Appendix E - Taylor Run Worksheet

CBG Recommendations to the City

Figures One and Two: Taylor Run Schematic

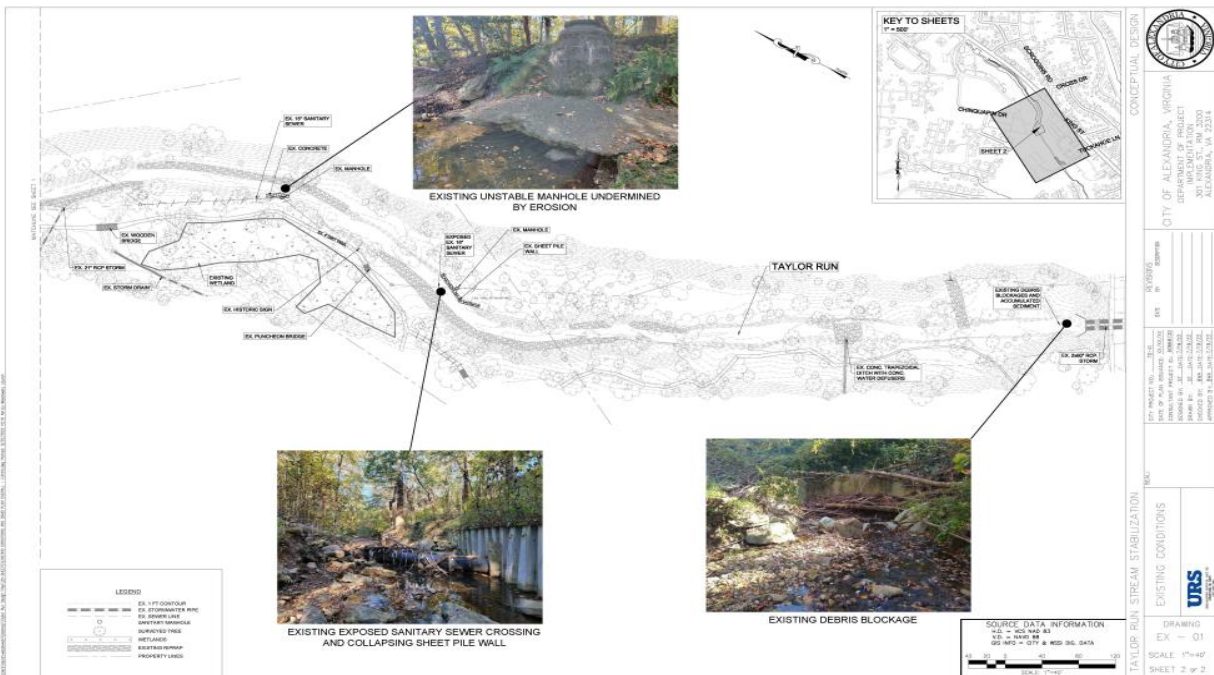
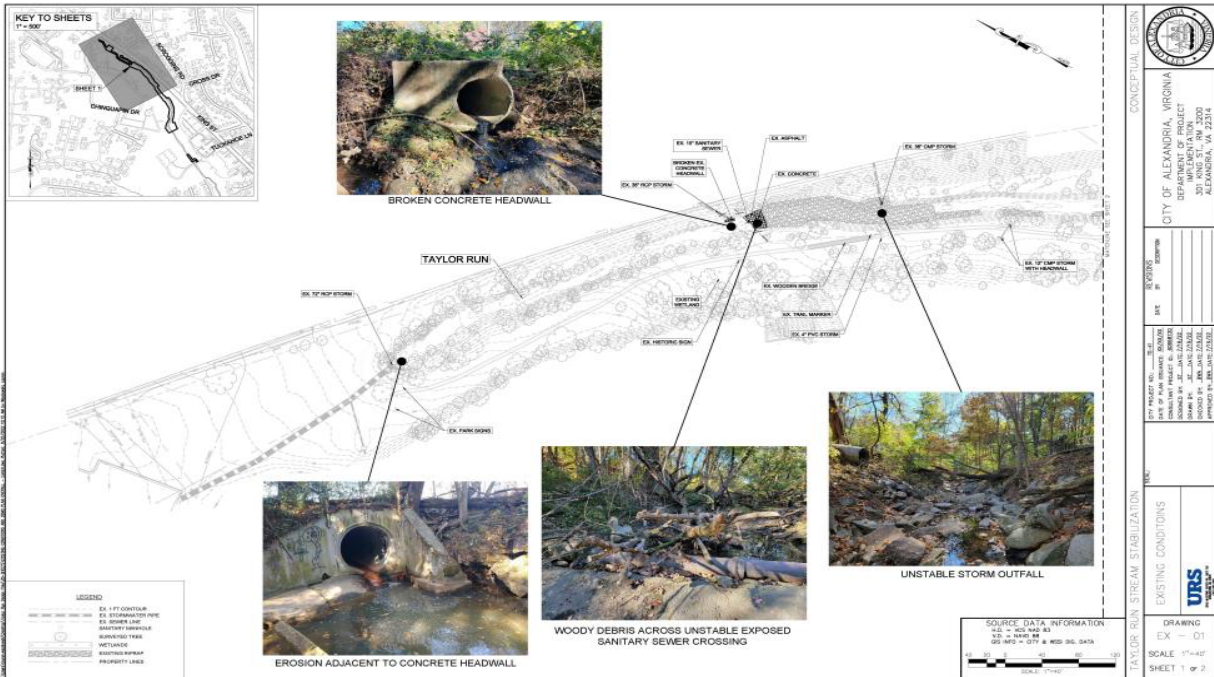
Construction Practices: Work on the infrastructure protection shall be done within the portions of the stream shown on the engineering proposals presented to the CBG in a manner calculated to have minimal impact on the wetlands and key forest communities adjacent to the stream and on the stream bed and banks. Selected options should be engineered to withstand flow rates. Construction paths should be clearly outside the boundaries of the wetlands. Between the upper sewer line crossover and the mid-stream crossover, trees on the Chinquapin Park side of the footpath should not be cut or harmed by affecting their root structure or otherwise.

Construction equipment access and work between the two sewer line crossovers should take place, to the extent possible, on the path in the middle of the park coming down the hill from Chinquapin Circle to the mid-stream crossover, and along the stream bed between the crossovers.
